Docket No.: STN 50-470F

March 29, 1983
LD-83-027

Subject: Response to Questions on Small Feedwater Line Break Methodology

15B.6 REANALYSIS OF SMALL BREAK LOSS OF FEEDWATER INVENTORY
EVENTS WITH THE LIMITING SINGLE FAILURE AND OFFSITE POWER AVAILABLE

Figure
15B-32

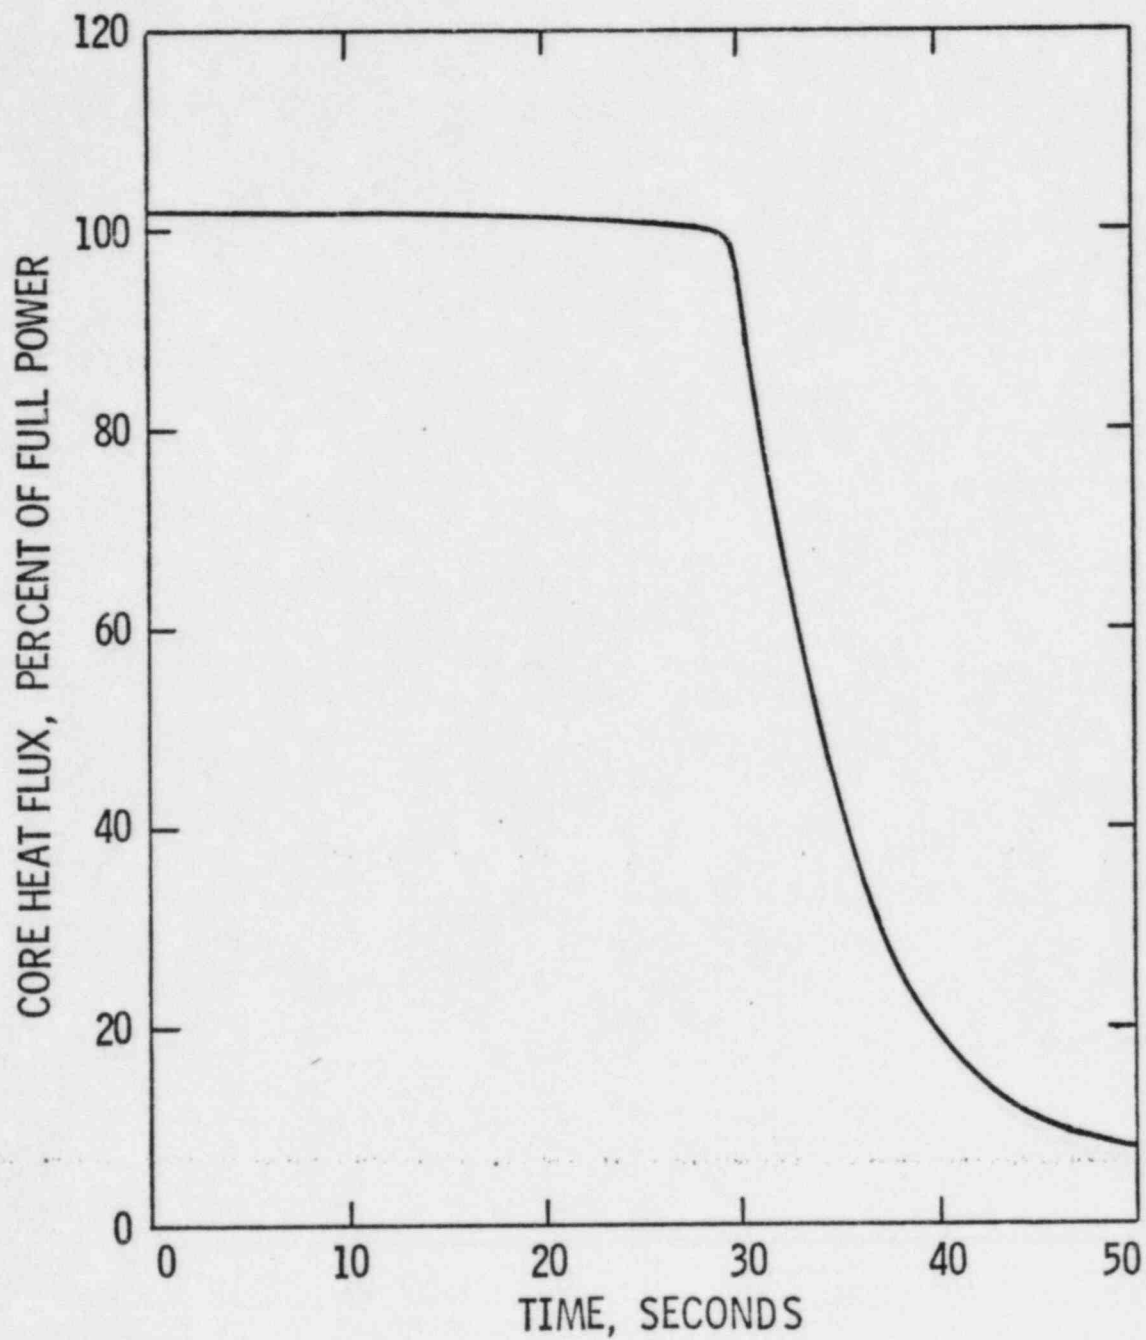
The dynamic behavior of the important NSSS parameters following the small break loss of feedwater inventory event with the failure to fast transfer to offsite power following turbine trip is presented in Figures 15B-32 to 39. The sequence of events provided in Table 15B-4 summarizes the important results of this event

The absence of subcooled feedwater flow causes a constant heatup and pressurization of the steam generators during the first 26.6 seconds which reduces the primary-to-secondary heat transfer rate. Rising primary coolant temperatures and pressures result. Due to the temperature reactivity feedback during this period core power is reduced from an initial value of 102% to 99.8% at 26.6 seconds.
